On May 24th, the Austin City Council is scheduled to hear zoning case #C14-2011-014 regarding a project known as Peaceful Hill Condominiums, also known as 8107 Peaceful Hill. I would like to express my opposition to this project and respectfully ask that you vote 'NO' on the SF-6 zoning request made by the applicant.

Engineering Report for Zoning and Platting Commission Hearing
Peaceful Hill Condominiums
Application: C14-2011-0141

May 20, 2012
Engineers Letter
Peaceful Hill Condominiums
Traffic, Number of Units and Drainage Issues
Application: C14-2011-0141

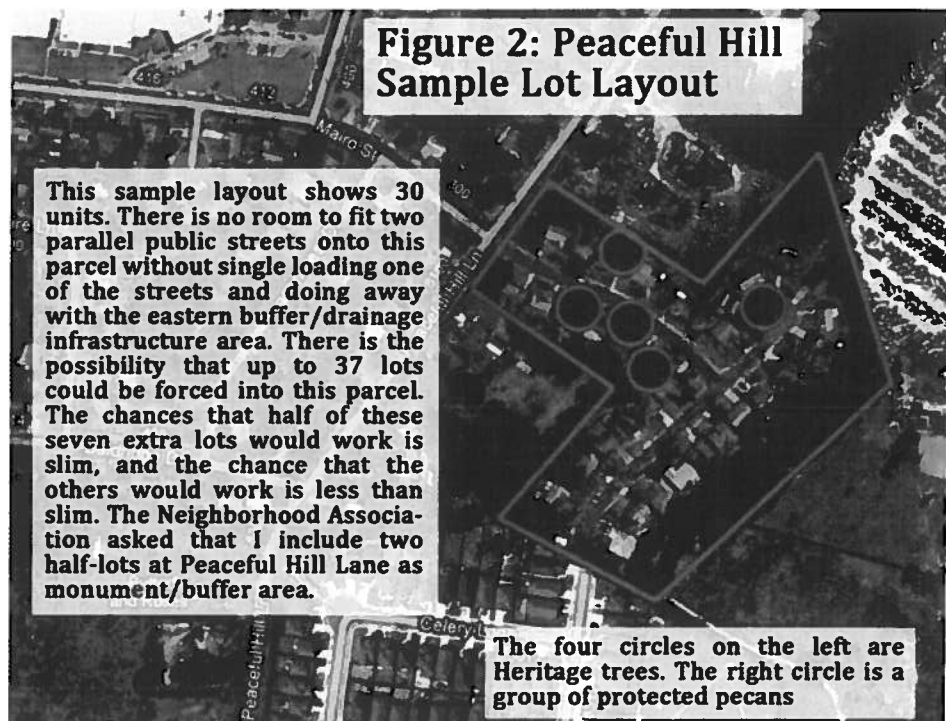
The SF-2 land use designation of 5,750 square feet per lot, assuming 20% (+/-) for roadways and drainage infrastructure, is only a starting point in any evaluation of the number of lots that a particular parcel can accommodate. Once this is determined, additional land must be removed from the assumption for complicating factors due to parcel shape, terrain and critical environmental features. In the case of this tract, all three of these complicating factors conspire to reduce the number of units that can be constructed on this specific parcel as described below and in Figure 2:

The parcel has an exceedingly odd shape. It is too narrow to allow for two parallel public streets creating a loop at any point, so a simple "T" street layout must be assumed. This reduces the number of lots.

There are four heritage trees on the site. These trees are located so that several to numerous lots cannot be constructed, reducing the number of possible lots further.

The parcel is quite flat and there is no alternative for underground connection of storm drain sewer lines. This means that the stormwater facilities cannot be constructed in deep ponds with a small surface area and must instead utilize shallow ponds with large surface area(s). Additionally, there is no defined drainage leading off the property and flow spreaders must be used to return stormwater discharge to its natural sheet flow condition. This requires more land area and further reduces the number of units that can be placed on the site.

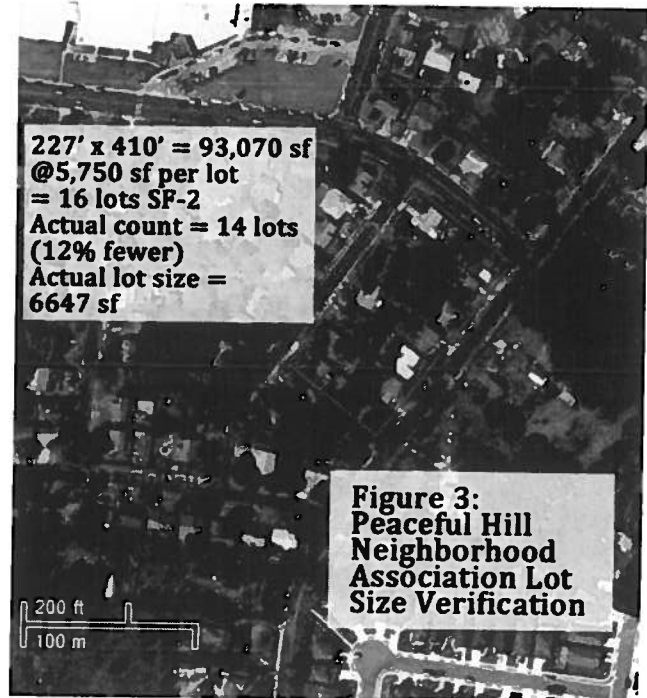
I have prepared an example site layout (see below), using cut and paste (Google Maps) lots from the adjacent Peaceful Hill neighborhood that demonstrates these things.

This layout includes 30 lots. The lots were physically cut and pasted from the Peaceful Hill neighborhood. Accurate measurement of the actual size of these lots is shown in Figure 3 and is found to be 12 percent larger than the minimum lot size for SF-2 of 5,750 feet.

This is the type of estimate I would prepare for my client at this stage of the development process. There is room to add several more lots if we are lucky, if the tree survey and negotiations with the neighborhood over buffers, and issues with the hazardous leaching in the wrecking yard are successfully addressed. These lots would number about three and are located: adjacent to two of the Heritage trees and adjacent to Park Ridge Gardens. In addition one or maybe even two more lots could be situated in the odd triangular leftover space in the

northernmost corner of the property, but these lots are very undesirable. There are also two half-lots at the entry on Peaceful Hill Lane. The Neighborhood Association asked me to leave these two half-lots vacant so as to serve as entry monument lots/buffer area.

The lots size chosen for this sample is also 12 percent larger than the minimum. Ideally, three or four additional lots could be picked up if their sized was reduced to the minimum, but because of the odd shape of this parcel and Heritage trees, it is not likely that any more than one or two lots could be picked up by reducing the size.

As figure one shows, there is not enough room to provide for a public street loop under SF-2, with houses on both sides of the street. There is enough room for a loop with houses only one side of half the loop, but all lots in the loop must be an odd size; approximately 75 feet x 75 feet and there is no room for drainage facilities on the downhill side, much less a buffer between this parcel and the adjacent parcels.

When the buffer(s) and room for drainage infrastructure are added in, even a loop that is half "single-loaded" is infeasible. The only way a loop is feasible is SF-6 zoning and a site plan using 3,750 sf "condo lots."

If all of the above assumptions and negotiations were successful, and two highly undesirable flag lots were added in the triangle, the lot count would be 37 or 38. In reality the lot count will likely end up at *no more than 33 lots* or 3.5 lots per acre if the tree survey and negotiations work out favorably for the developer.

Figure Two shows about 50 to 75 feet of vacant land to the east and south of the sample lots. This area is for stormwater facilities and flow spreading. Unless stormwater is piped off-site (discussed below) discharge must leave the site as sheet flow and further, it must be discharge equally along all parts of the site where it would naturally be discharged.
